Subject: Docket No. 2018-0165  
Instituting a Proceeding to Investigate Integrated Grid Planning  
Hawaiian Electric's Reply Comments

# **Hawaiian Electric**

## **Integrated Grid Planning Stakeholder Feedback Summary**

Figure 1: Nominal Capital Cost Comparison For Hawai’i Adjusted Single Axis Tracking PV

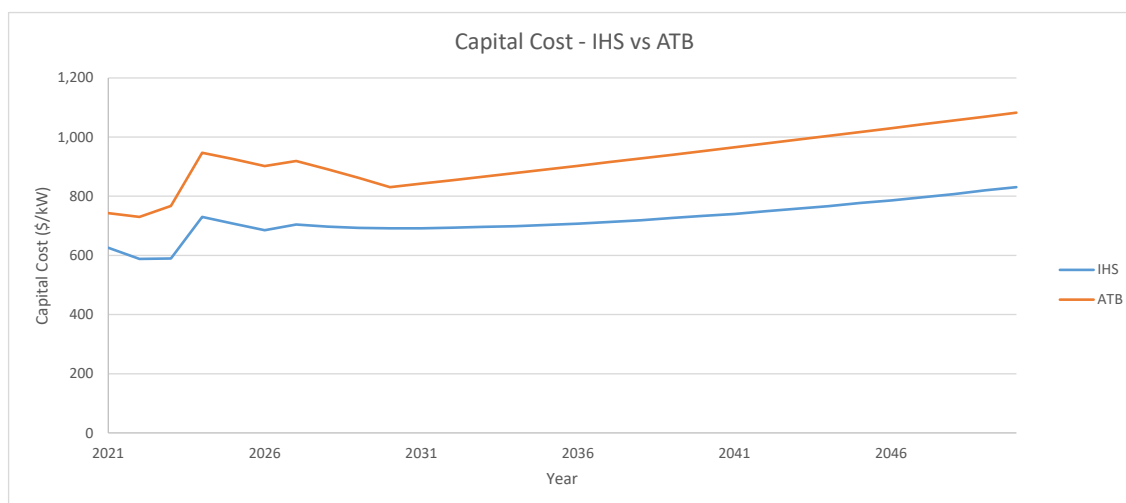
- **Ulupono Initiative<sup>25</sup> asked why Hawaiian Electric used IHS Markit for the cost forecasts for the main utility-scale generation and storage technologies, instead of a public source such as the NREL Annual Technology Baseline? The IHS Markit forecast differs significantly from NREL ATB; is there reason to expect it to be better? There should be a preference for publicly available data.**

IHS provides much more granular data for the resource costs. For PV this includes breakdowns of the module, inverter, balance of system, installation and development costs for fixed tilt and single axis tracking systems. For storage, similar category breakdowns are provided along with cost streams for multiple duration systems. The category breakdowns are also helpful for estimating cost reductions for co-locating paired PV+BESS systems. This allows the Company to create resource costs for paired solar and storage projects where components for standalone solar and storage may be shared. Figure 1 compares the nominal capital costs of the IHS and ATB forecast for single axis tracker solar with the same “Hawaii” factors applied as noted in the Inputs and Assumptions Report. The IHS costs track lower than ATB’s forecast.
